PLANT NAME: Oconee Units 1-2-3

Amdt. to OL/changes to Appendix A tech specs...notorixed 6/6/77...to incorporate changes to the pressurization heatup and cooldown limitations, based on the attached report, "Analysis of Capsule OC11-C from Duke Power Company Oconee Unit 2 Reactor Vessel Materials Surveillance Program".....
BAW-1437 - MAY 1977

Re: Oconee Nuclear Station
Docket Nos. 50-269, -270, -287

Pursuant to 10CFR50, §50.90, please find attached a proposed amendment to the Technical Specifications for the Oconee Nuclear Station, Appendix A to Facility Operating Licenses DPR-38, -47, and -55. This proposed amendment incorporates changes to the pressurization heatup and cooldown limitations for Oconee Unit 2. These changes are based on the attached report, "Analysis of Capsule OC11-C from Duke Power Company Oconee Unit 2 Reactor Vessel Materials Surveillance Program," BAW-1437, June, 1977.

UNIT 2
REACTOR COOLANT SYSTEM
NORMAL OPERATION HEATUP LIMITATIONS
APPLICABLE FOR FIRST 6.0 EFY
OCONEE NUCLEAR STATION

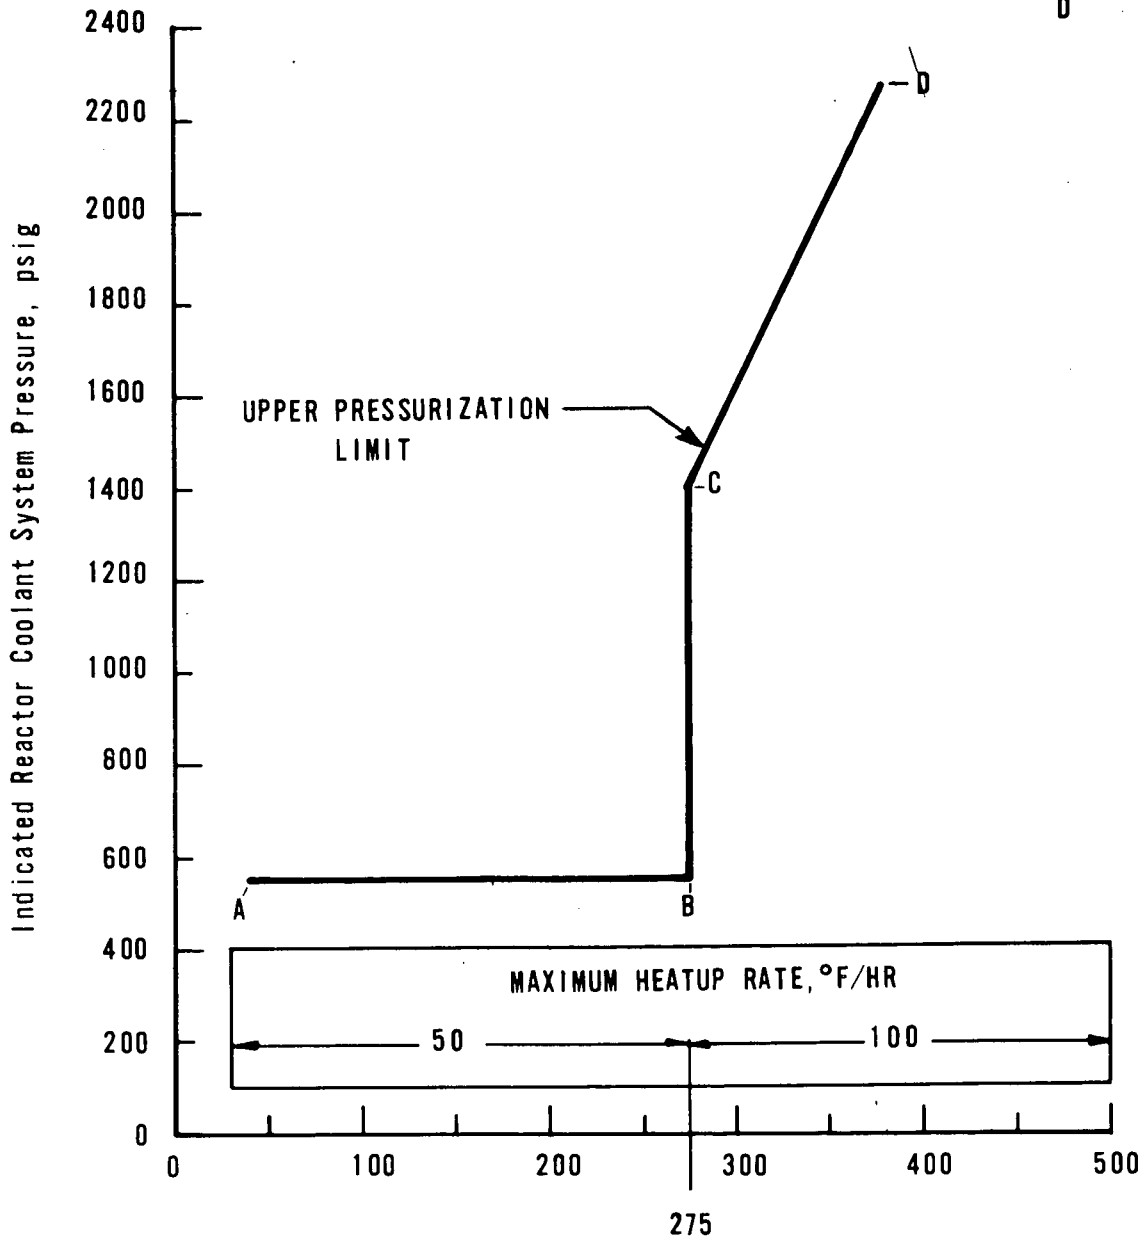
Replacement pages for the Oconee Nuclear Station Technical Specifications are attached. Proposed changes are identified by vertical lines in the margins.

Heatup rates and allowable combinations of pressure and temperatures shall be limited in accordance with Figure 3.1.2-1A Unit 1
3.1.2-1B Unit 2
3.1.2-1C Unit 3.

POINT	TEMP.	PRESS.
A	40	550
B	275	550
C	275	1400
D	380	2275

Figure 3.1.2-2B

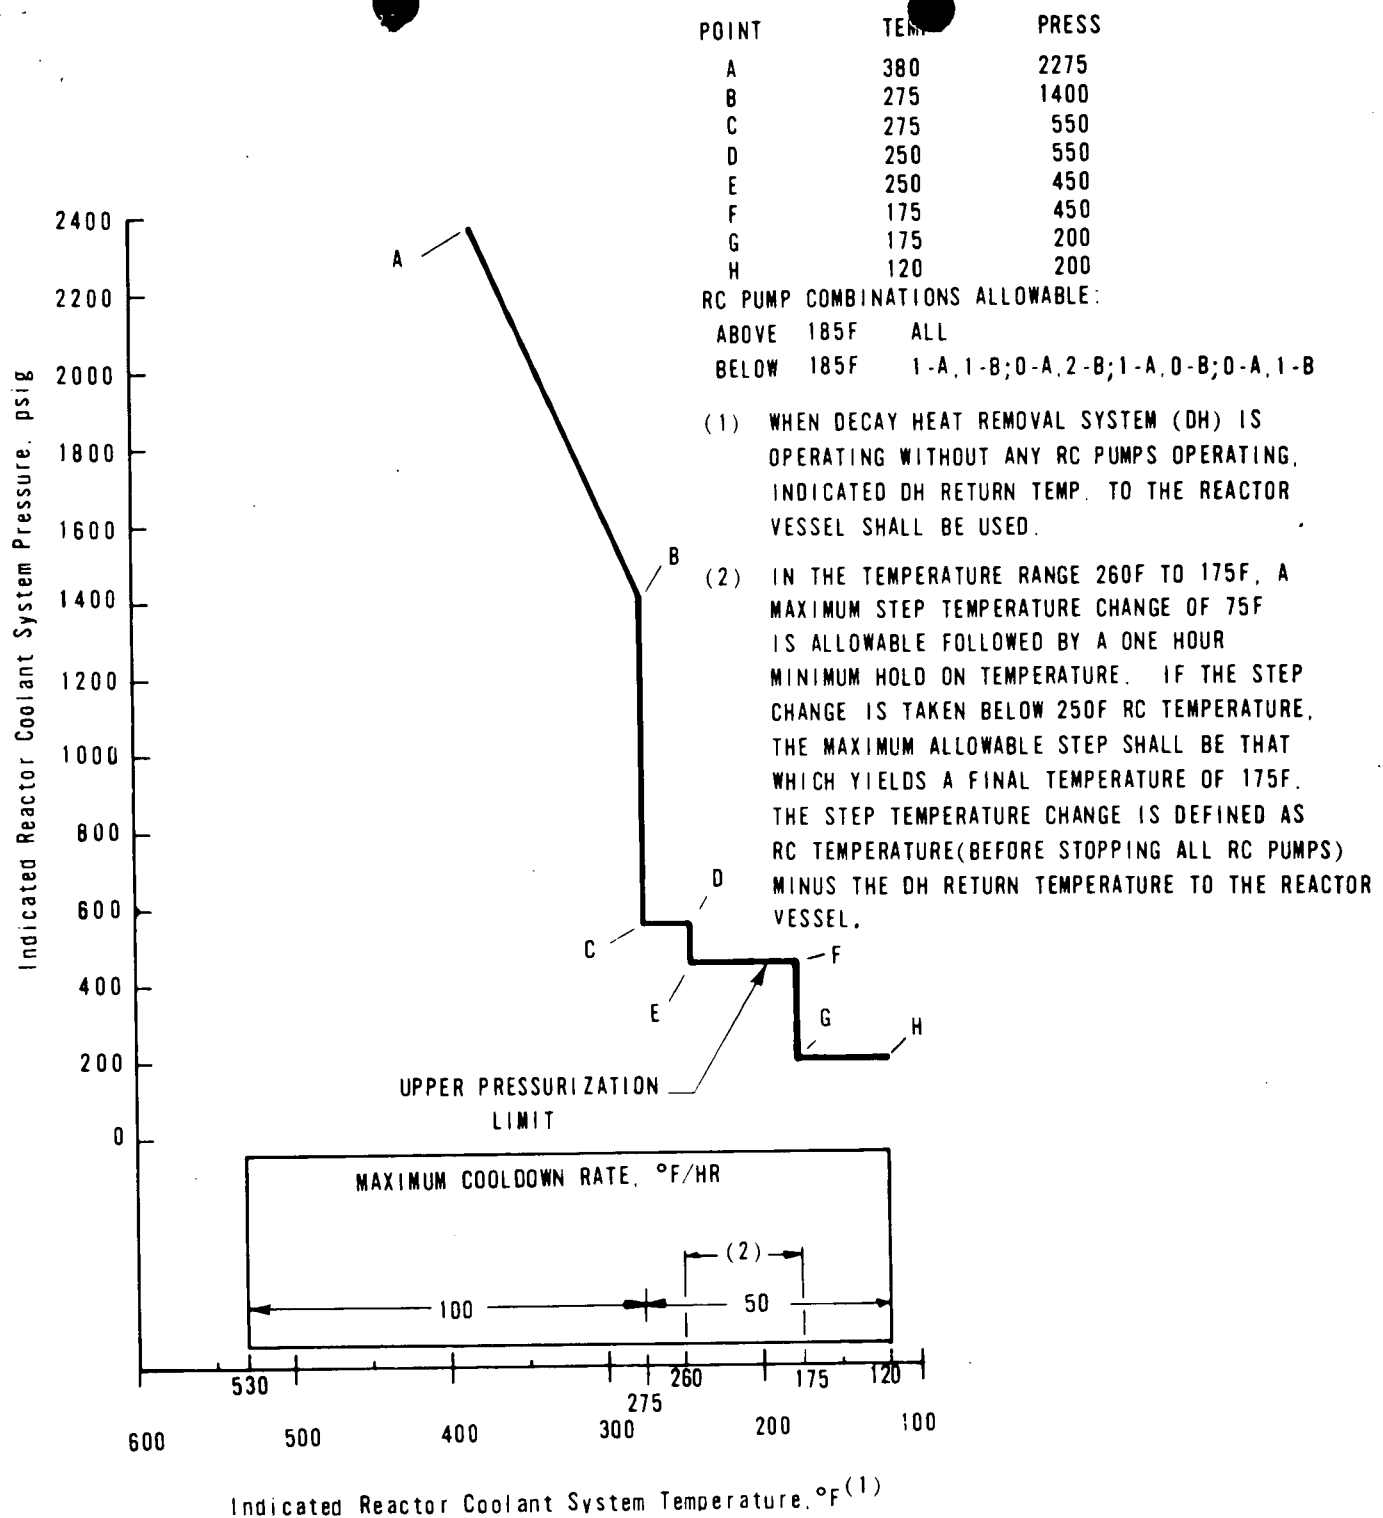
Cooldown rates and allowable combinations of pressure and temperature shall be limited in accordance with Figure 3.1.2-2A Unit 1
3.1.2-2B Unit 2
3.1.2-2C Unit 3.

UNIT 2
 REACTOR COOLANT SYSTEM
 NORMAL OPERATION COOLDOWN LIMITATIONS
 APPLICABLE FOR FIRST 6.0 EFY
 OCONEE NUCLEAR STATION

Figure 3.1.2-3B

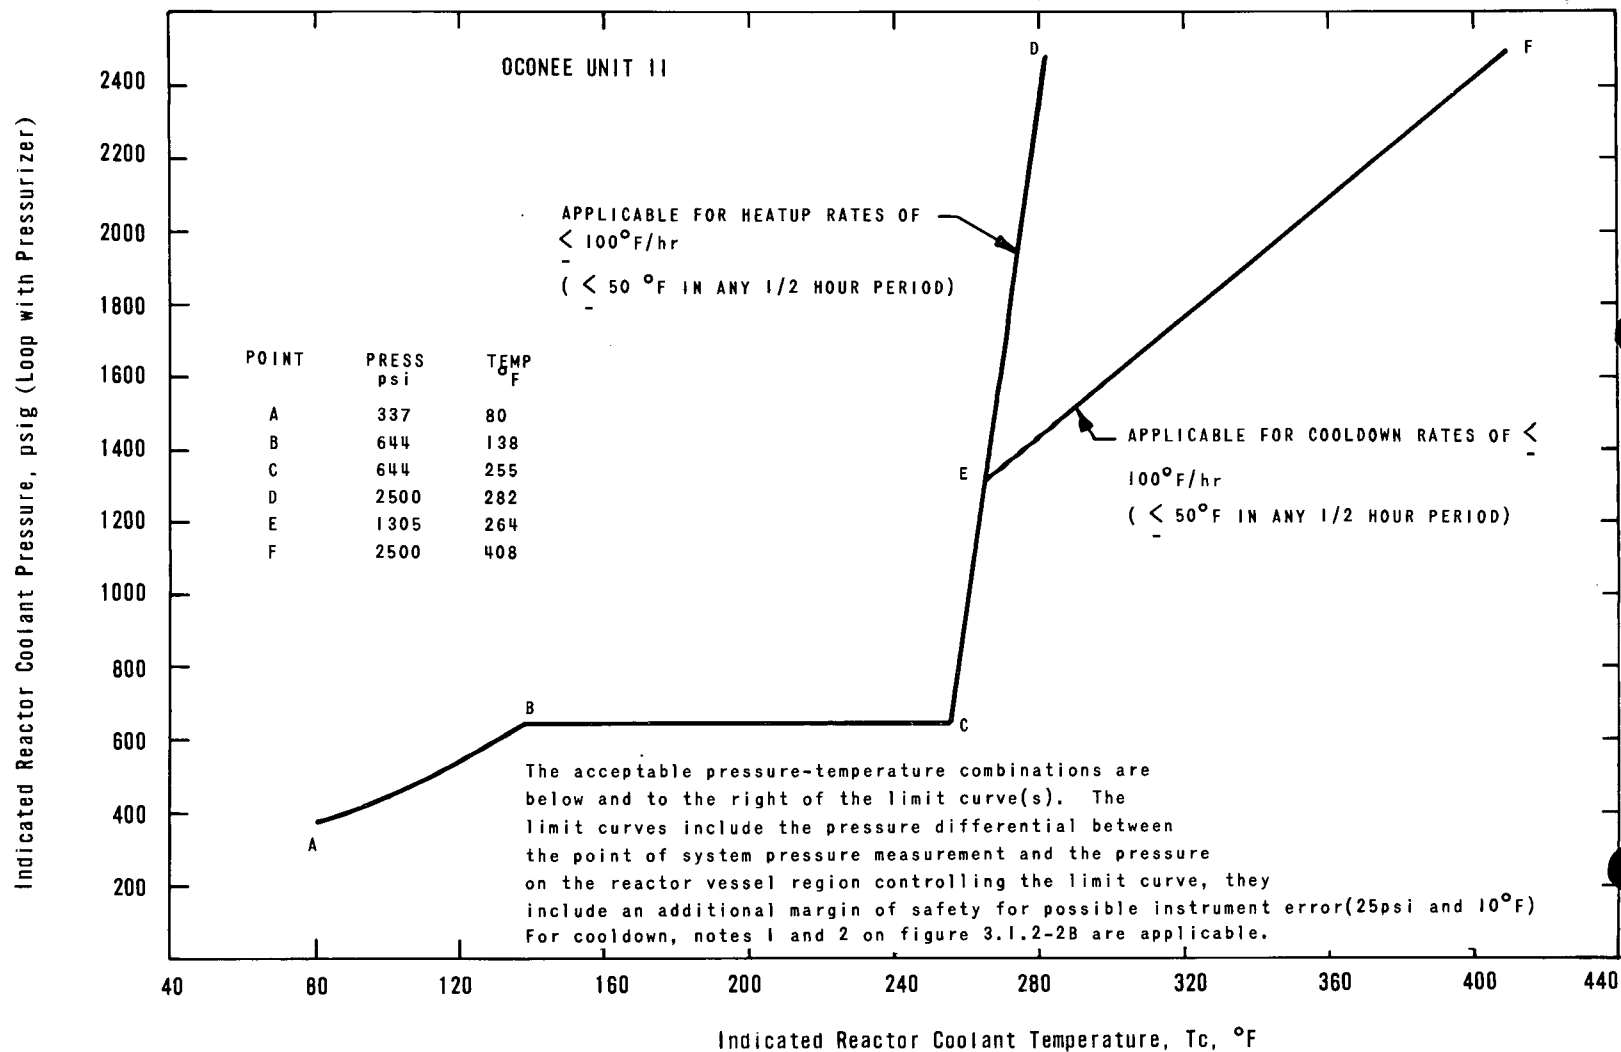
For thermal steady state system hydro test the system may be pressurized to the limits set forth in Specification 2.2 when there are fuel assemblies in the core under the provisions of 3.1.2.1 and to ASME Code Section III limits when no fuel assemblies are present provided the reactor coolant system is to the right of and below the limit line in Figure 3.1.2-3A Unit 1
3.1.2-3B Unit 2.

UNIT 2
 REACTOR COOLANT SYSTEM
 INSERVICE LEAK AND HYDROSTATIC
 TEST AND COOLDOWN LIMITATIONS
 APPLICABLE FOR FIRST 6.0 EFY
 OCONEE NUCLEAR STATION
